Subject: Comments on 2AM-MEL1631 Design Report for Saline Effluent Treatment Plant (SETP) Upgrade and Operation & Maintenance Manual

Please find attached Agnico Eagle Mines Limited (Agnico Eagle)'s response to Crown-Indigenous Relations and Northern Affairs Canada (CIRNAC) and Environment and Climate Change Canada (ECCC)'s comments on the Design Report for Saline Effluent Treatment Plant (SETP) Upgrade and Operation & Maintenance Manual..

Figure 1: SETP Conceptual Flowsheet

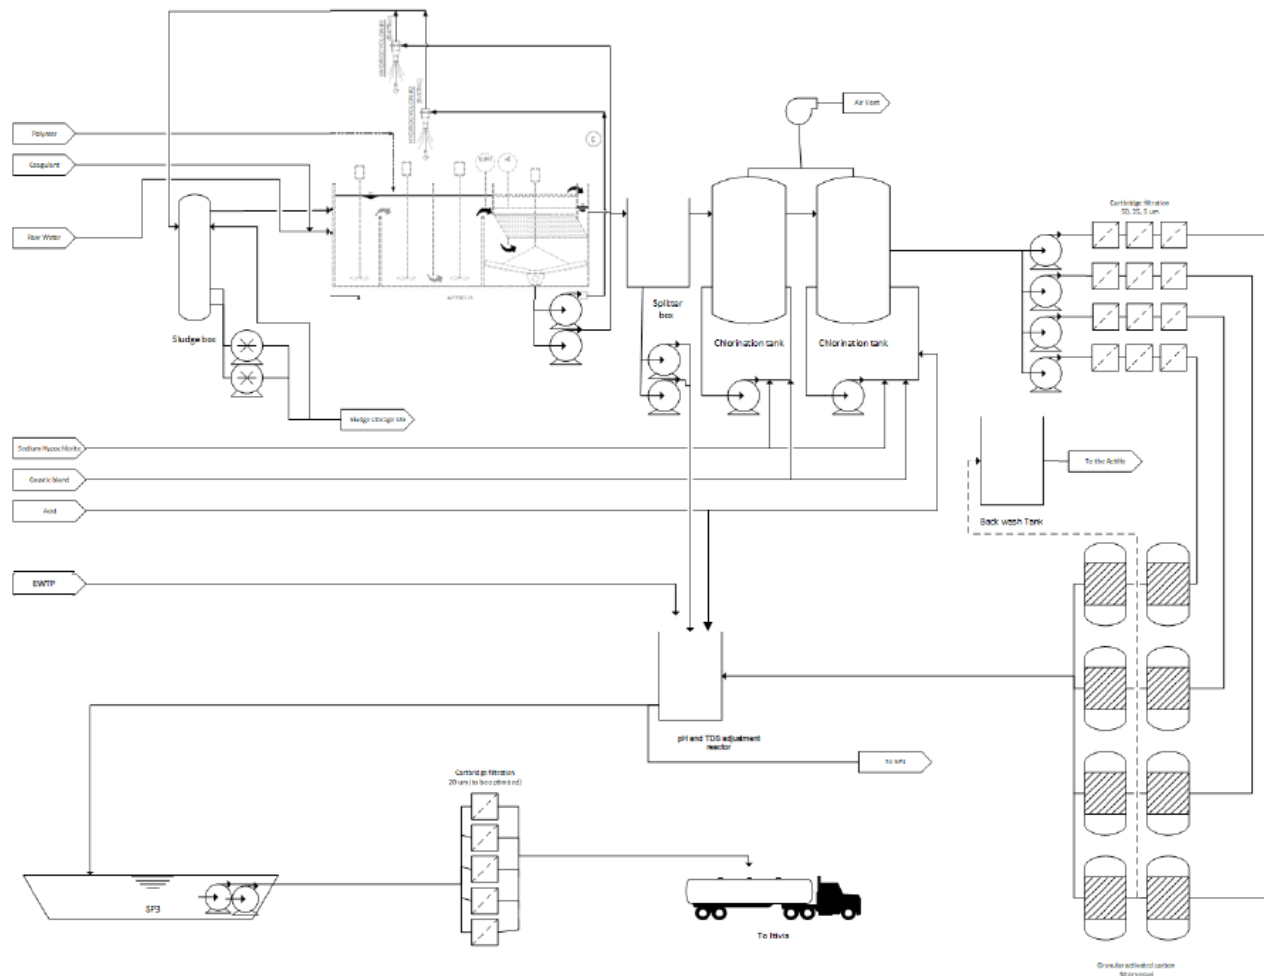
It does not appear that the Saline Effluent Treatment Plant (SETP) will reduce TDS levels. The proponent should identify what treatment will be used to consistently reduce TDS concentrations prior to discharge to Melvin Bay.

- the treatment target for non-acutely lethality include passing the marine invertebrate test using *Acartia tonsa*.
- ECCC recommends that the proponent specify the targets for TDS and ammonia as a numerical range or maximum.
- ECCC recommends that the proponent provide information on how they will achieve TDS reductions in the effluent.

- *The TDS reduction will be achieved as presented in section 3.6 of the report. (6526-680-132-REP-001), which follows the same approach as described in the approved SETP Design Report from 2019. Figure 1 (below) presents the conceptual flowsheet of the SETP including the TDS adjustment reactor.*

It should be noted that the modifications to the SETP described in the report under review (6526-680-132-REP-001, May 2020) do not relate at all to how TDS is

adjusted but rather relate to upgrades to SETP. The key changes in the SETP as compared to 2019 are the following:

- Improve TSS removal by retrofitted the Multiflo unit (classical lamella clarifier) to an Acitflo unit (sand ballasted lamella clarifier)*
- Increase in capacity for breakpoint chlorination (improve ammonia removal)*
- Additional granular activated carbon (GAC) filters for higher dichlorination*
- Supplemental reagent dosing capacity and control for improved treatment performance*
- Upgrade of pumping capacity to manage a higher throughput to meet the approved target of 1,600 m³/d discharge to sea*

Figure 1: SETP Conceptual Flowsheet

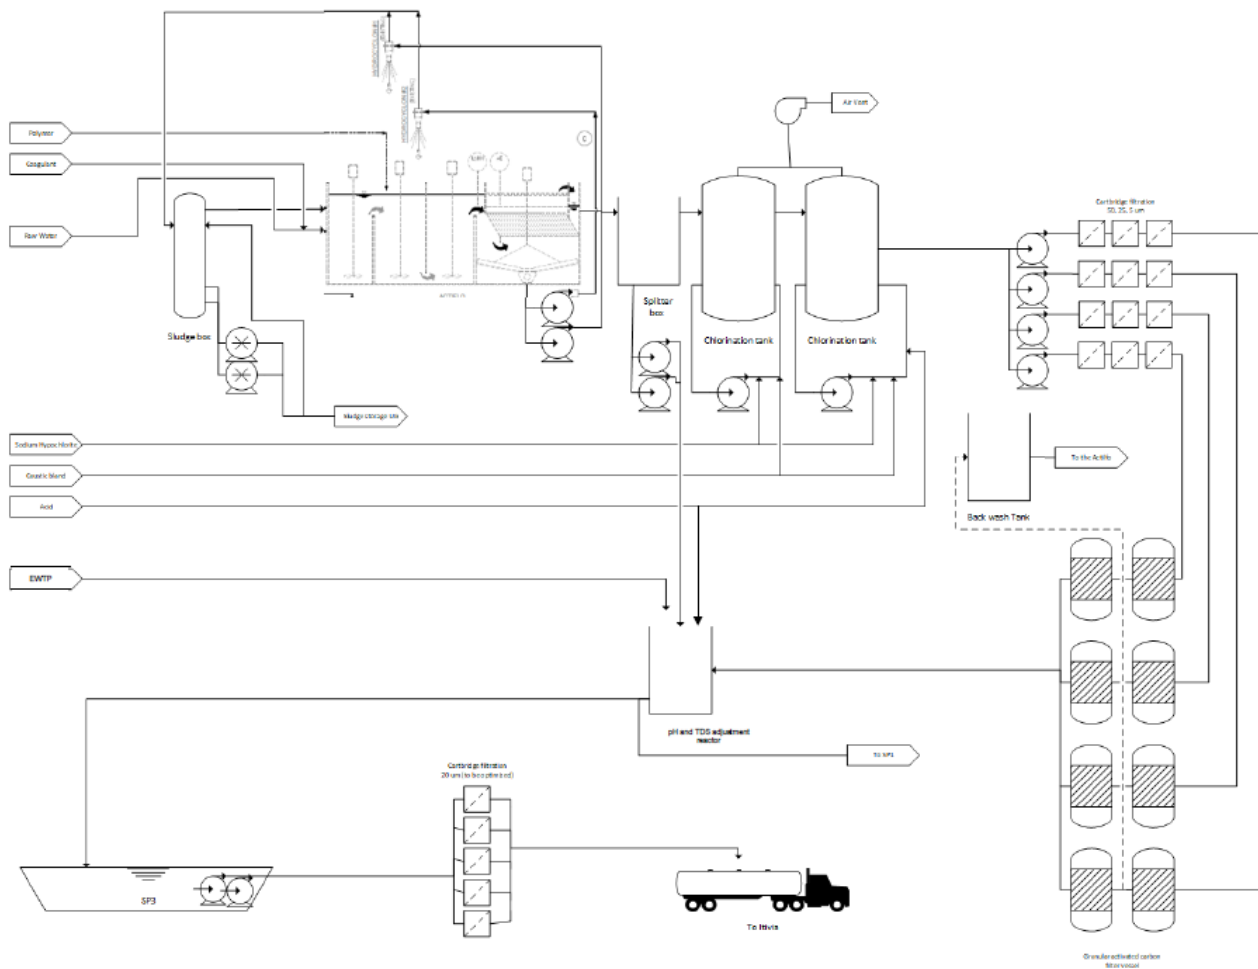
The design report states that the total dissolved solids (TDS) and ammonia concentration targets will be set to be non-acutely toxic for the three-spined stickleback. CIRNAC notes that although the treatment for ammonia is described in detail in the design report, the methodology and the design of effluent TDS treatment is not provided.

Given that effluent TDS treatment may be required, CIRNAC recommends that the licensee include the methodology and the design of effluent TDS treatment in the design report.

- *The TDS reduction will be achieved as presented in section 3.6 of the report. (6526-680-132-REP-001), which follows the same approach as described in the approved SETP Design Report from 2019. Figure 1 (below) presents the conceptual flowsheet of the SETP including the TDS adjustment reactor.*

It should be noted that the modifications to the SETP described in the report under review (6526-680-132-REP-001, May 2020) do not relate at all to how TDS is adjusted but rather relate to upgrades to SETP. The key changes in the SETP as compared to 2019 are the following:

- *Improve TSS removal by retrofitted the Multiflo unit (classical lamella clarifier) to an Acitflo unit (sand ballasted lamella clarifier)*
- *Increase in capacity for breakpoint chlorination (improve ammonia removal)*
- *Additional granular activated carbon (GAC) filters for higher dichlorination*
- *Supplemental reagent dosing capacity and control for improved treatment performance*
- *Upgrade of pumping capacity to manage a higher throughput to meet the approved target of 1,600 m³/d discharge to sea*
